Stanley Park Causeway Cycling and Walking Safety Improvements

HUB is very pleased that the Ministry of Transportation and Infrastructure (MoTI) is moving forward with the planning of safety improvements to the pedestrian and cycling paths along the Stanley Park Causeway. We appreciate being consulted at an early phase of the design process and would like to take this opportunity to provide feedback on the draft design proposal presented to us in January which is titled "preliminary cross-section option for Causeway improvements".

After reviewing the Ministry of Transportation and Infrastructure's preliminary cross-section option for Causeway improvements, HUB is very concerned that the plans for the west side are not safe for the volume and speed of bicycle traffic both now and in the future nor is the proposal to ban pedestrians feasible as it will most likely be ignored. The plans for the east side in general are safer due to lower cyclist speed and greater width and can likely be improved further with our recommendations below.

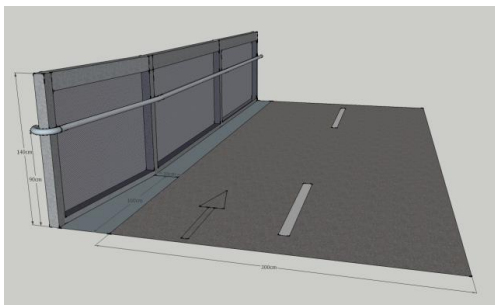
Fencing is a major safety improvement that will prevent cyclists from falling onto the roadway. However, care needs to be taken with the design and placement of the fencing so it does not increase other hazards.

- i) **Smooth surface** - The fencing should have a smooth surface and not have any poles or protrusions that could cause a cyclist to crash or that could result in a secondary collision when a cyclist is falling or out of control as a result of a collision with a pole or pedestrian or slipping on ice or debris.
- ii) **Fencing starts** - The start of the fencing should be placed such that cyclists are unlikely to collide with it and to minimize the severity of a collision should one occur.

In this example, from Bicycle Network, the fence is 1.4m high with mesh panels between, and flush with, the vertical elements providing a smooth surface that cannot catch or snag a bike or rider.

Federation Trail bridge over Werribee River shows clean smooth surfaces and a good safe height of fence. Highly recommended. If on a slope a hand rail would be required and in fitting this, the support brackets should be horizontal to avoid snagging of handlebars.

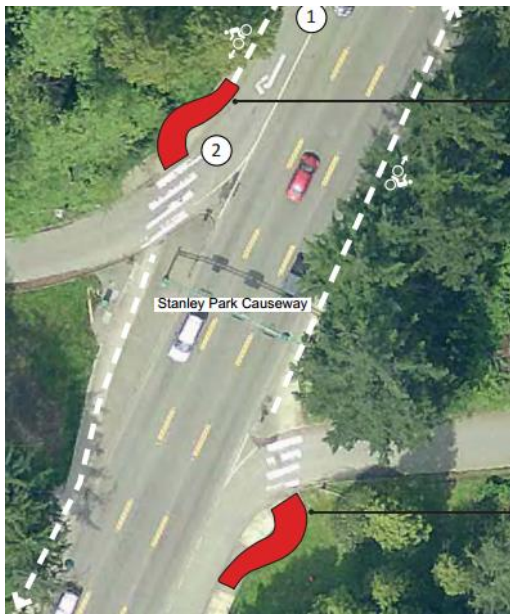
- ii) **Improved safety at intersections with causeway** - Intersections should be re-aligned for better visibility. The path should be raised through intersections and marked in green with zebra stripes and elephant feet. Cycling should be allowed through the intersections. Drivers on exit/entrance ramps should be required to yield to those on bikes and on foot. The Stanley Park Cycling Plan (<http://vancouver.ca/files/cov/stanley-park-cycling-plan-final.pdf>) has a similar suggestion on Page 18. Below is their image:

The recommendation is to create “Jug Handles”, though maybe larger than the ones in the picture. The objective is to create a perpendicular intersection. Perhaps road radius could be decreased as well. By raising the path, it is more obvious that path traffic has right of way over road traffic and will also encourage motor vehicles to slow down. Covering the raised path with the green colourized asphalt and adding elephant feet, zebra stripes and yield signs and yield markings on the pavement would make the intersections perfect.
